Certificate of Appropriateness for 415 E Washington Ave

October 28, 2019

Proposed Work

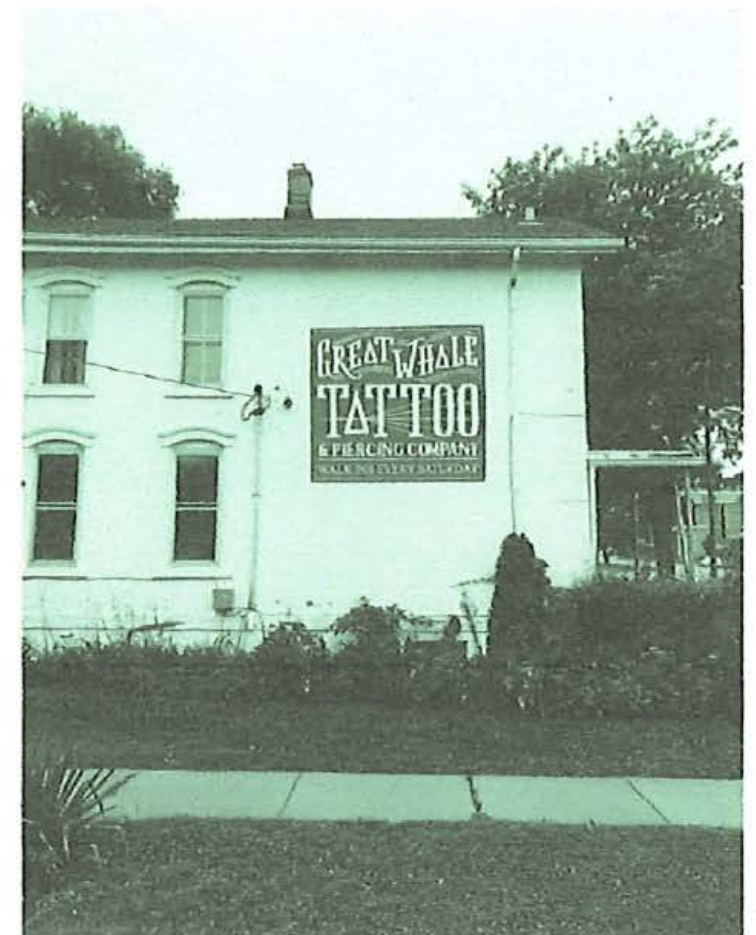
sign dimensions: 8 ft x 8 ft
hung approximately at 14 feet

1. Wall signage be installed with stainless steel fasteners, which are installed in the masonry joints, not in the bricks
2. As long as the sign is no larger than what is currently proposed, the Landmarks Commission does not need to review changes in dimension or location as recommended by the Urban Design Commission.

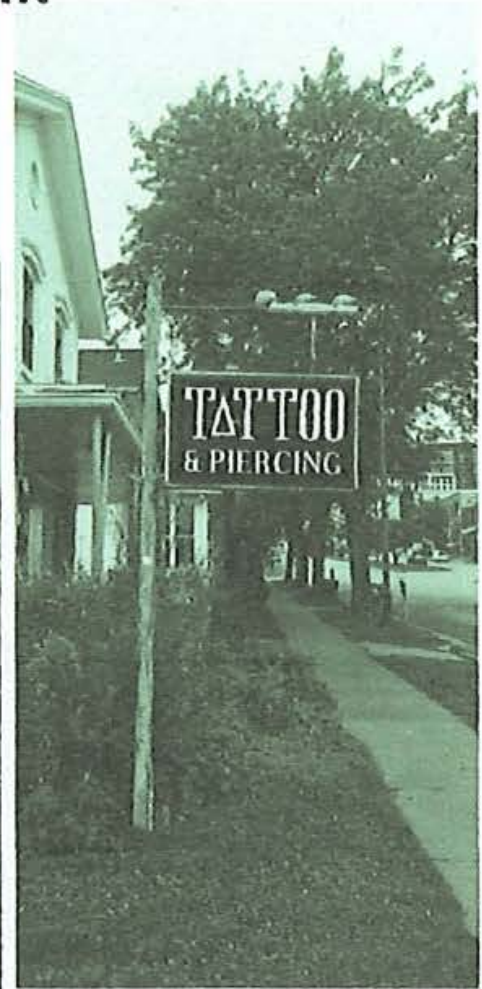
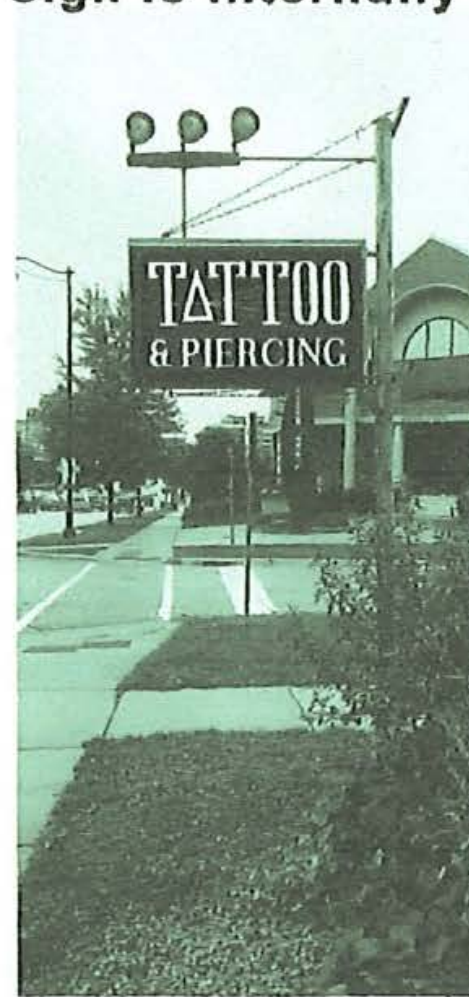
**keeping existing hardware
repaint pole, remove lights
sign is internally lit**

**vinyl graphic
20 x 18 inches**
